EPA Response to Comments

**EPA Region 8**  
**Underground Injection Control (UIC) Program**  
**Response to Public Comments**

**Class III Area Permit No. SD31231-00000, Aquifer Exemption Decision**  
**And**  
**Class V Area Permit No. SD52173-00000**

**Powertech (USA) Inc.**  
P.O. Box 448  
Edgemont, South Dakota 57735

**Figure J. Locations of earthquakes occurring between 1872 – 2013 in southwest South Dakota from the South Dakota Geological Survey website.**

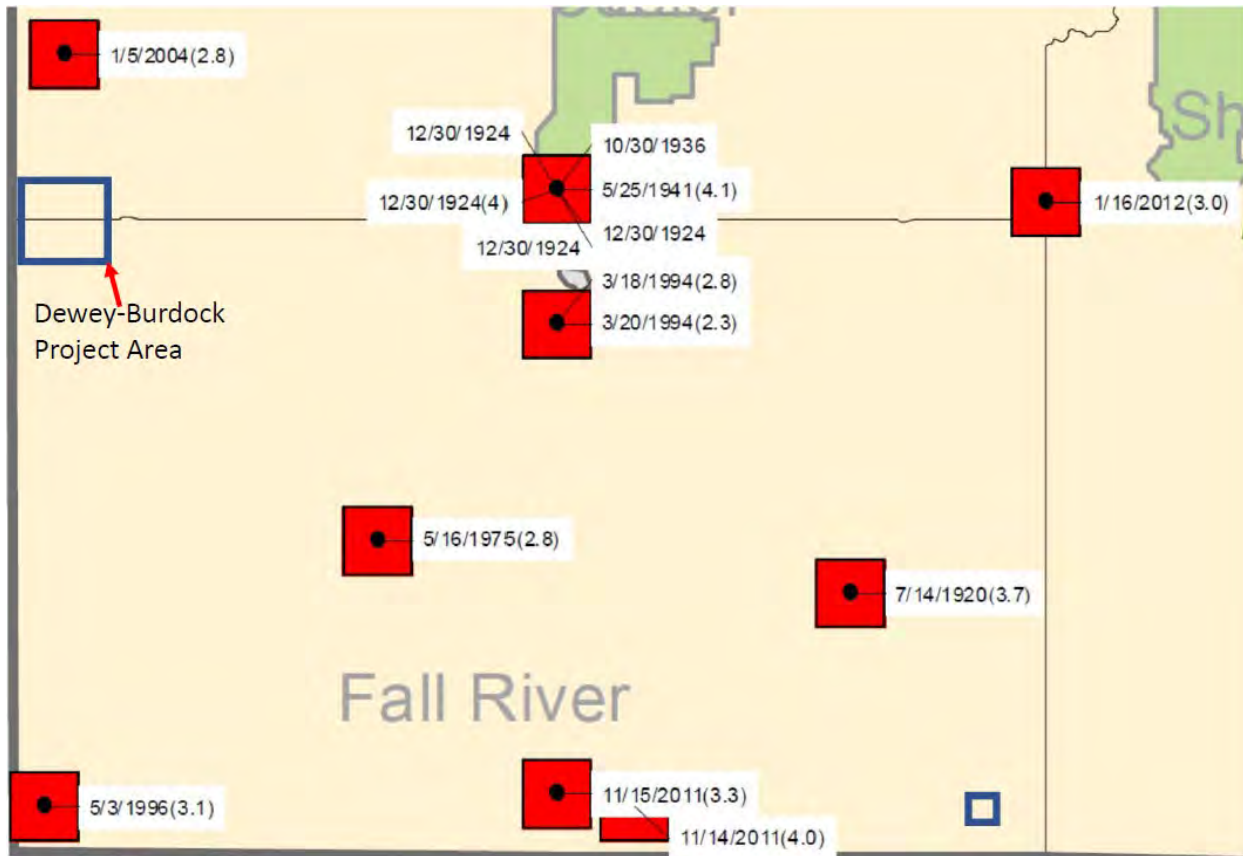
Figure J shows locations of earthquakes that have occurred between 1872 - 2013 in southwestern South Dakota including the earthquakes mentioned by the commenter. This map is available on the [South Dakota Geological Survey website](#).

Figure J shows the nearest recorded earthquake to the Dewey-Burdock Project Site is the one that occurred on January 5, 2004, located north of the Project Site. Figure K shows this earthquake location on the [USGS Earthquake Hazards Program interactive map](#). This earthquake was located at latitude 43.598°N and longitude 103.995°W. This location plotted on Google maps with the Dewey Fault zone location added shows that this earthquake was not located in the Dewey Fault zone.

**Figure L. The relative locations of the Dewey-Burdock Project Site and Town of Buffalo Gap locations in the Black Hills and Inyan Kara groundwater flow direction.**

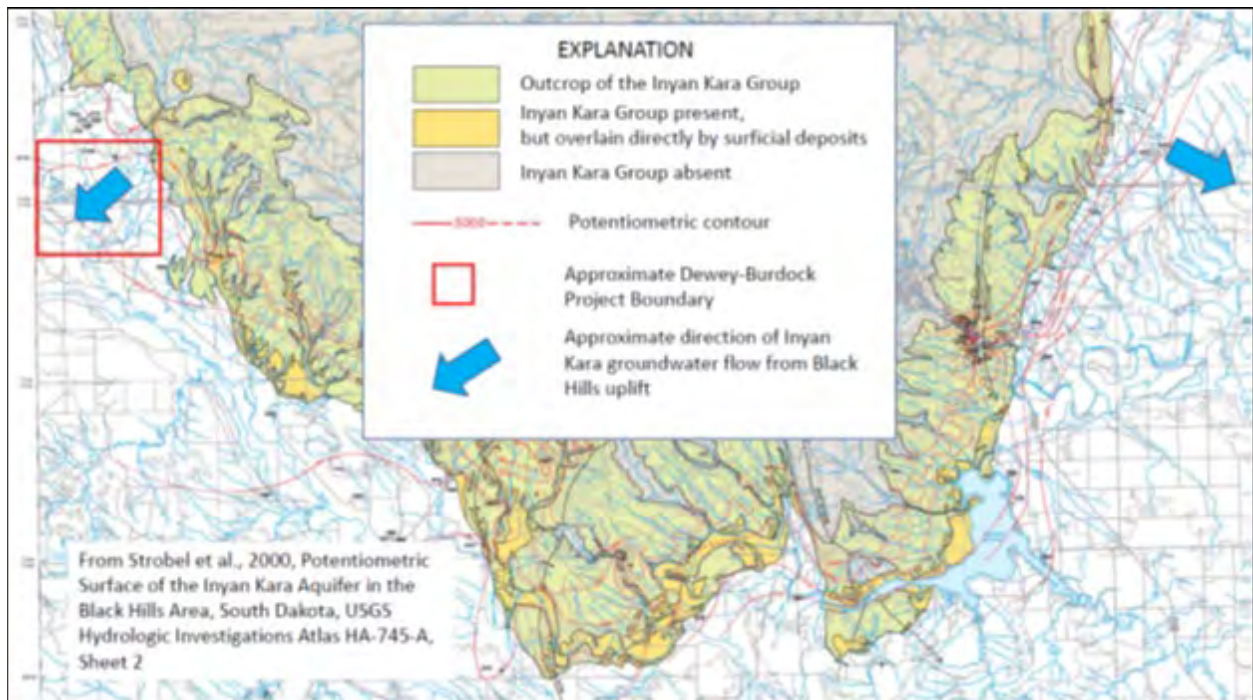
EPA has investigated the injection zone aquifer flow directions from the Dewey-Burdock Project Area relative to the Town of Buffalo Gap, South Dakota. Figure L is the southern portion of Sheet 2 from Strobel et al., 2000, which shows that the Dewey-Burdock Project Site and Buffalo Gap are located on opposite sides of the Black Hills. (Strobel et al., 2000). The Inyan Kara aquifer groundwater flow at the two locations is in opposite directions, as indicated by the potentiometric surface contours that approximately follow the dip of geologic strata away from the Black Hills uplift.

**Figure M. Minnelusa aquifer groundwater flow directions around the southern portions of the Black Hills based on Figure 16 from Carter et al., 2001.**

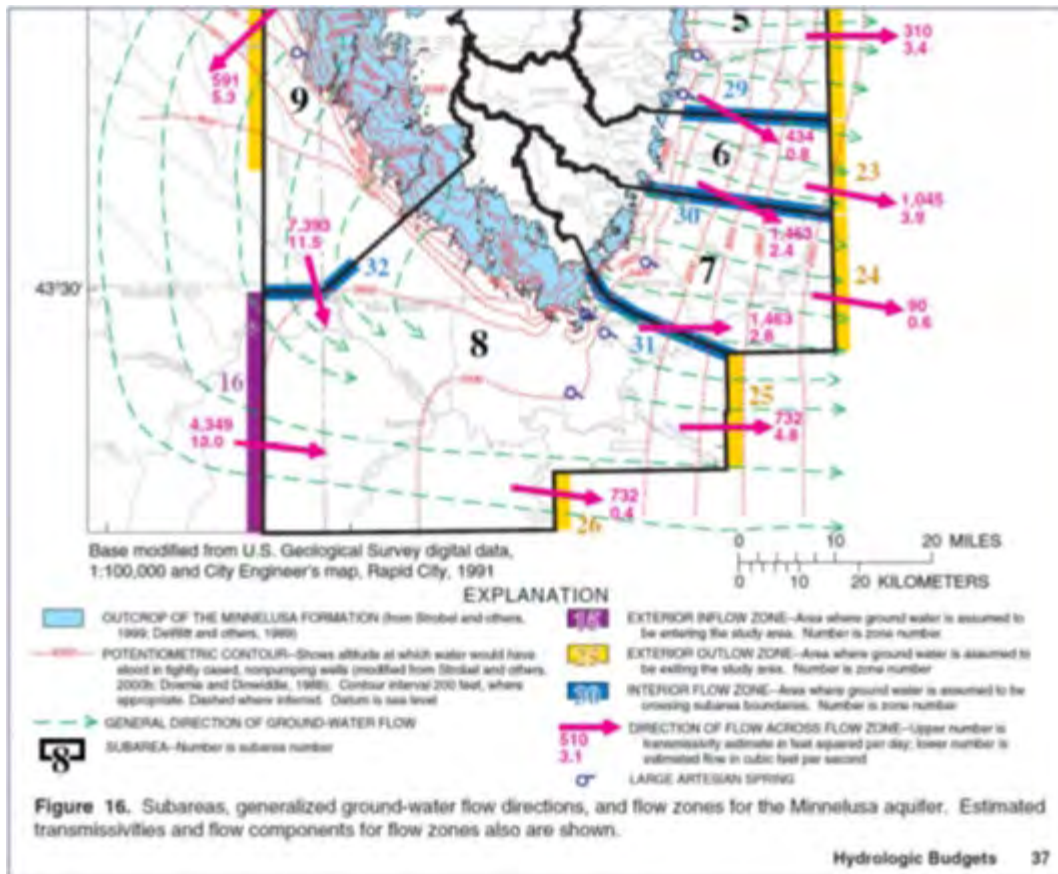
Figure M below shows the groundwater flow directions of the Minnelusa injection zone aquifer at the Dewey-Burdock Project Site and at the Town of Buffalo Gap from Carter et al., 2001, *Hydrologic budgets for the Madison and Minnelusa aquifers, Black Hills of South Dakota and Wyoming, water years 1987-96*: USGS Water-Resources Investigations Report 01-4119. Buffalo Gap is located near the southern border in subarea 7 and the Dewey-Burdock site is located near the pink arrow crossing the boundary between subareas 8 and 9. Based on this Minnelusa aquifer flow direction map, Class V injectate into the Minnelusa aquifer at the Dewey-Burdock project site will not reach the Town of Buffalo Gap.

Based on aquifer flow direction information, the groundwater flowing from the Dewey-Burdock site will not reach Buffalo Gap. Because the proposed Dewey-Burdock operations will have no impact on the aquifers present at Buffalo Gap, EPA does not agree that the geographic scope of the EJ Analysis should be revised to include the Town of Buffalo Gap. For the same reason, EPA does not agree that it would be appropriate to extend enhanced public participation and outreach specifically to the residents of Buffalo Gap.

**Figure N. Elevation of the Minnelusa Formation top surface (Source: Carter and Redden, 1999, Sheet 2)**

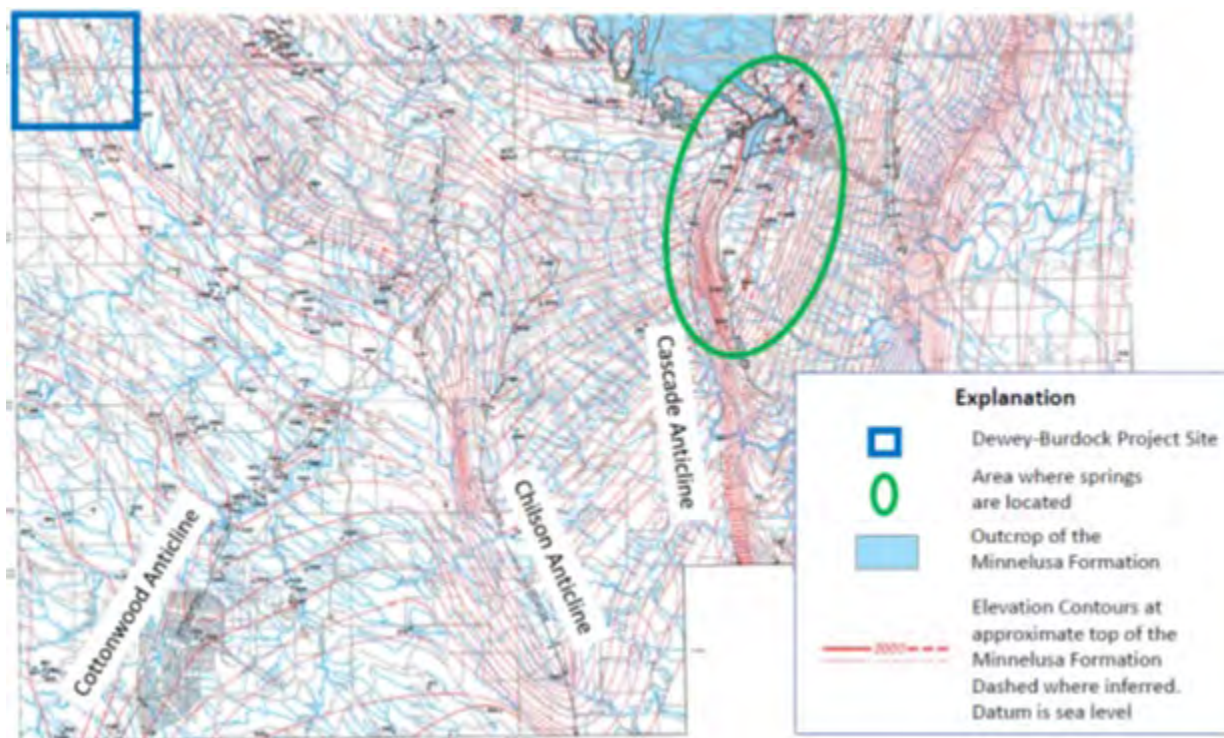
locations where the Minnelusa groundwater flows to the ground surface are at springs near the Minnelusa outcrop around the Black Hills. Figure N shows the elevation of the top of the Minnelusa Formation from the Sheet 2 map from Carter and Redden, 1999. (Carter and Redden, 1999, Sheet 2) The springs are located in the green circle in Figure N; the Dewey-Burdock Project Area is located inside the blue square. The Minnelusa Formation where the springs are located, occurs at a higher elevation than the Minnelusa injection zone in the Dewey-Burdock Project Area. Although the Minnelusa Formation top elevation is not the same as the aquifer groundwater level and the direction of the Minnelusa Formation dip is not exactly the same as the groundwater flow direction, relative formation top elevation and direction of formation dip are a useful approximation in this case. EPA concludes that injectate flowing from the Dewey-Burdock Project Site would have to flow uphill/upgradient to reach these springs and thus would not reach the locations of these springs. In addition, the Cottonwood, Chilson and Cascade anticlines located south of the Black Hills are like hills raising the Minnelusa Formation top to a higher elevation and deflect Minnelusa groundwater flow further south away from the locations of these springs.

Based on this analysis, EPA concludes the Class V disposal well injectate will not travel to the locations of Minnelusa springs to be discharged to the ground surface; therefore, Class V injection activities will not impact surface water, including the Cheyenne River, the Cheyenne River Indian Reservation, the Pine Ridge Indian Reservation, or other downstream communities.

**Figure P. Minnelusa aquifer groundwater flow direction map from Figure 17, Driscoll et al., 2002**

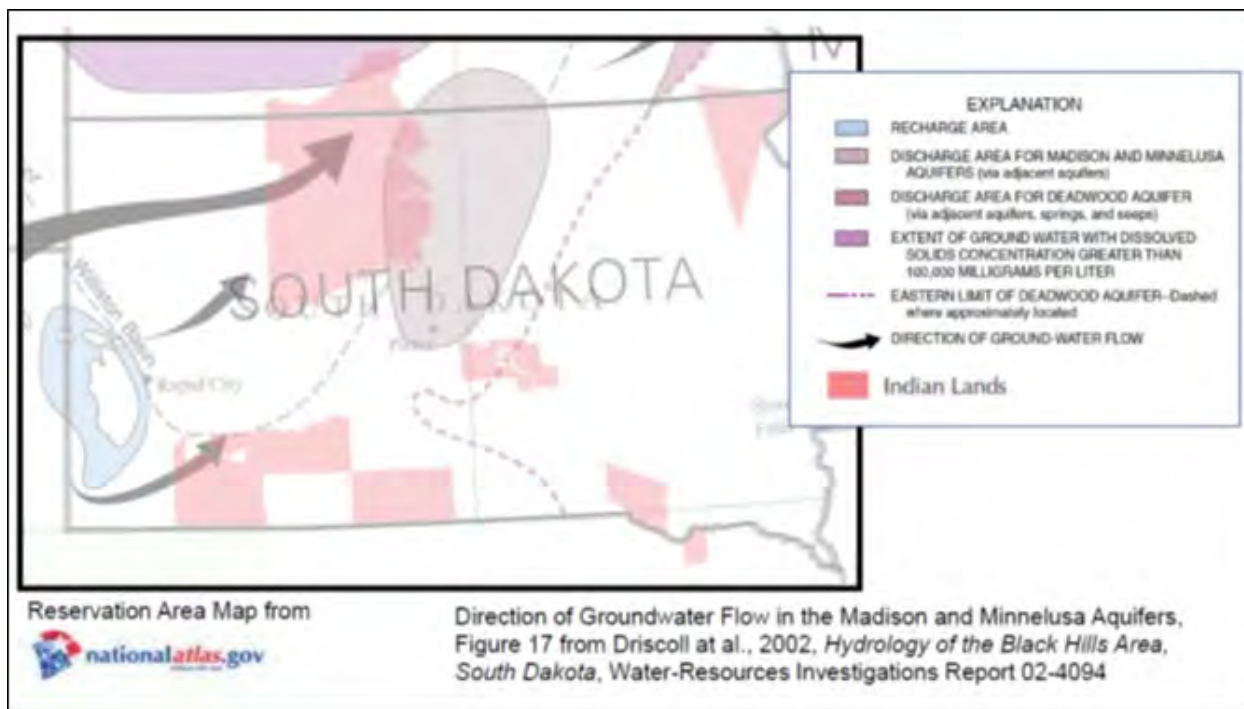
area in the Black Hills to a discharge area identified in this paper. As shown in the map in Figure P, the authors hypothesize that the Minnelusa aquifer groundwater flows from the Dewey-Burdock site and around the southern end of the Black Hills toward the Williston Basin, crossing underneath the northwestern portions of the Pine Ridge Reservation. The map shows a discharge area for the Madison and Minnelusa aquifers in an area that coincides with the eastern portion of the Cheyenne River Indian Reservation.

Figure Q. Locations of springs emanating from or passing through the Minnelusa aquifer, from Figure 8 of Naus et al., 2001.

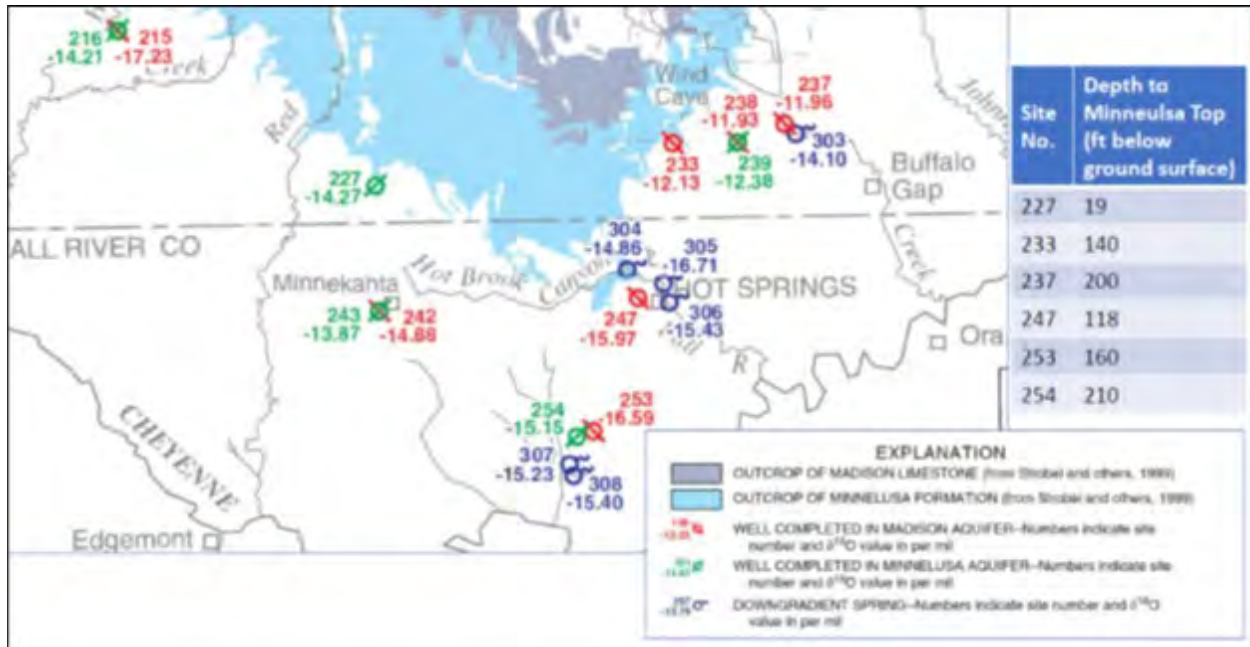
EPA examined oil and gas test wells located near the northwest portion of the Pine Ridge Indian Reservation to determine the depth of the Minnelusa aquifer in the area and found the top of the Minnelusa aquifer is more than 3,800 feet below ground level in this area, which is too deep to flow to ground level. Springs emanating from, or passing through, the Minnelusa aquifer occur where the top of the Minnelusa aquifer occurs closer to the ground level. For example, at the springs shown in Figure Q, from Figure 8 of Naus et al. 2001, the top of the Minnelusa is approximately 200 feet or less below ground level, based on nearby private well logs. Based on the elevation of the top of the Minnelusa Formation shown in Carter and Redden, 1999, the springs occur in areas located at a higher elevation than the Minnelusa injection zone at the Dewey-Burdock Project Site. Carter and Redden, 1999, provides estimates of how the Chilson and Cascade anticlines affect the Minnelusa Formation elevation. As a result, the flow path of Class V injectate would be deflected to the south and would essentially have to flow uphill to reach these springs where Minnelusa groundwater flows to the surface.

**Figure R. Map showing area of possible upward leakage from the Madison and Minnelusa aquifers into Inyan Kara aquifers and extent of the Arikaree and Ogallala aquifers (Sources: Peter et al., 1986, Figure 8 and Weeks, et al., 1988, Figure 1)**

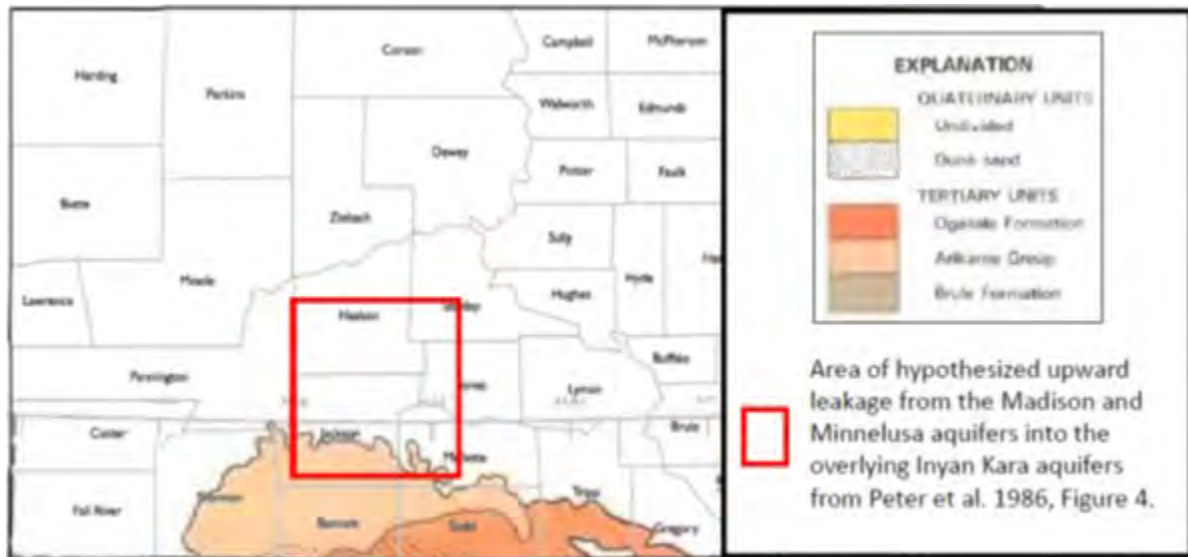
Based on lineament analysis and review of Inyan Kara groundwater quality data, Peter et al., 1986, hypothesized upward leakage from the Madison and Minnelusa aquifers into the Inyan Kara aquifers in an area within portions of Jackson, Melette, Haakon, Stanley and Jones Counties in South Dakota. (Peter, K.D., et al., 1986, *Lineaments: Significance, Criteria for Determination, and Varied Effects on Ground-Water Systems—A Case History in the Use of Remote Sensing*, Geotechnical Applications of Remote Sensing and Remote Data Transmission, ASTM STP 967, A. I. Johnson and C. B. Petterson, Eds., American Society for Testing and Materials, Philadelphia, 1988, pp. 46-68.) Figure R shows the location of this area overlaid on a map of the Arikaree and Ogallala aquifers in South Dakota documented in Weeks, et al., 1988. (Weeks, J.B., et al, 1988, *Summary of the High Plains Regional Aquifer-System Analysis In Parts of Colorado, Kansas, Nebraska, New Mexico, Oklahoma, South Dakota, Texas, and Wyoming*, USGS Professional Paper 1400-A, at p. A4) Upward leakage from these lower aquifers into the Inyan Kara aquifers does not necessarily result in upward leakage into the overlying Arikaree and Ogallala aquifers in this location. EPA reviewed logs from oil and gas test wells in Jackson County and determined the top of Inyan Kara is 2800 to 2900 feet below ground surface. Approximately 2000 feet of overlying strata, most of which are confining zones, separate the top of Inyan Kara aquifer from the Arikaree and Ogallala aquifers. EPA concludes that Inyan Kara groundwater does not flow into the Arikaree and Ogallala aquifers on the Pine Ridge Indian Reservation.

EPA has investigated the area identified as a discharge area for the Minnelusa and Madison aquifers in the area shown in Figure P that coincides with the eastern portion of the Cheyenne River Reservation. The discharge area represents the area where Madison and Minnelusa groundwater is moving upward into the Inyan Kara aquifers (Downey, J.S and Dinwiddie, G.A, 1988, *The Regional Aquifer System Underlying the Northern Great Plains in Parts of Montana, North Dakota, South Dakota, and Wyoming-Summary*, USGS Professional Paper 1402-A). Based on oil and gas test well logs EPA reviewed, the depth to the top of the Minnelusa aquifer in the area of discharge is approximately 3,000 feet below ground level and the top of the Inyan Kara aquifer is approximately 2,000 feet below ground level. According to Howells, 1979, (Sheet 1) the Pierre Shale is present at the surface of the eastern portion of the Cheyenne River Indian Reservation. (Howells, L., 1979, *Geohydrology of the Cheyenne River Indian Reservation, South Dakota*, USGS Hydrologic Investigations Atlas HA-585, Sheet 1) Most of the intervening geologic units between the top of the Inyan Kara, including the Pierre Shale, are confining units. Based on this information, EPA concludes that neither the Minnelusa nor the Inyan Kara injection zones discharge to ground level at the Cheyenne River Indian Reservation. EPA examined test oil and gas well logs and found that along the eastern edge of the Cheyenne River Indian Reservation the top of the Inyan Kara ranges from 1500 in the southeast to 2800 in the northeast. The top of the Inyan Kara deepens from south to north as it descends further into the Williston Basin. Driscoll et al., 2002, characterizes Inyan Kara groundwater as moderately saline with increasing salinity toward the deep parts of the Williston and Powder River Basins. Because of the depth and salinity of the Inyan Kara aquifers at the Cheyenne River Indian Reservation, these aquifers would not be developed for use.

Figure T. Pass Creek alluvium cross-section and the Burdock Area Pond locations for the Class V disposal option.

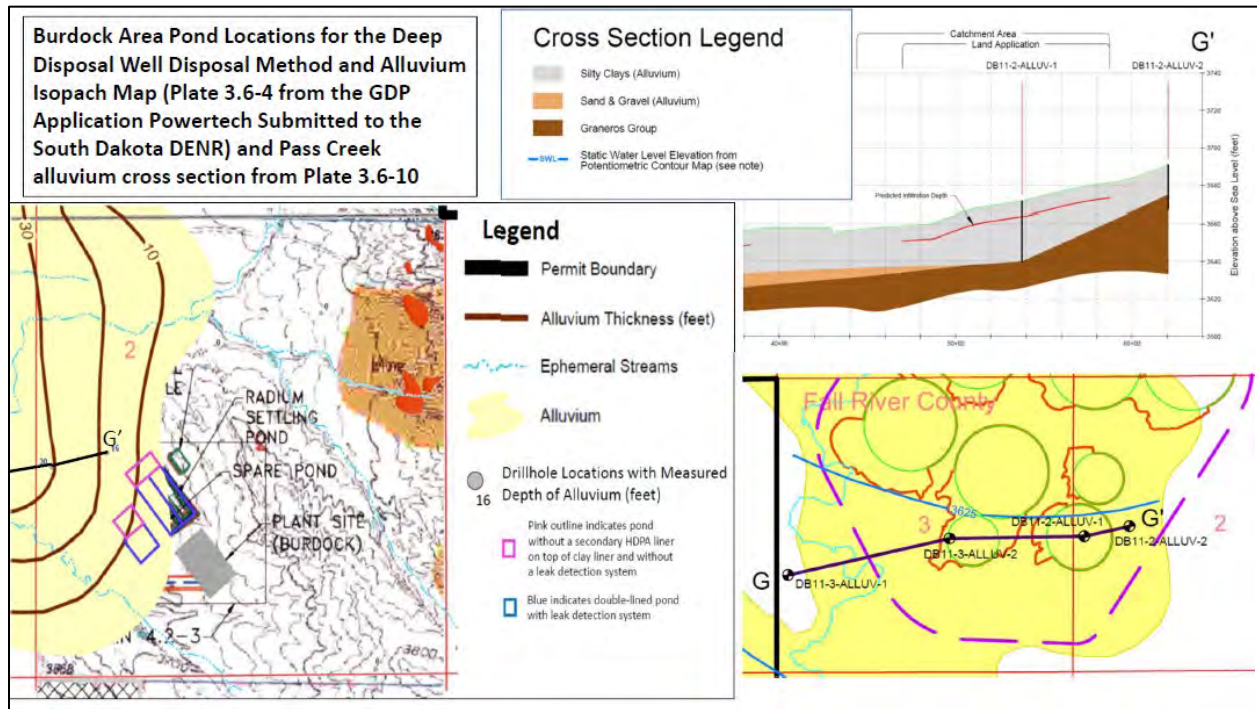
EPA does not agree with Powertech about the potential impacts from a pond leak in this area. EPA performed an analysis of the geological conditions underlying the Burdock Area Ponds to evaluate impacts from the potential leaking of ponds. EPA has concerns that although the ISR waste fluids would have been treated to remove radium, the stored water would still contain byproduct material and high TDS reject water from the reverse osmosis treatment system. Leaking from ponds in this area have the potential to affect alluvial aquifers. Plate 3.6-10 in the Groundwater Discharge Permit Application shows cross-sections of the Pass Creek alluvium and Appendix 3.6-A contains logs from Pass Creek alluvial

Because of EPA’s concern about potential effects to these alluvial aquifers, EPA included a condition in Part II, Section I.4.a of the Class III Area Permit requiring the Permittee to submit information to the EPA Region 8 Air and Radiation Division to determine the applicability of the 40 CFR part 61, subpart W regulations, and if necessary, receive construction approval from EPA. If CAA subpart W applies to these ponds, Powertech will need to meet subpart W requirements. The surface impoundment design, construction, and operating requirements are found under 40 CFR § 264.221(c) which requires two or more liners, installation of a leak detection system, and a leachate collection and removal system between such liners.
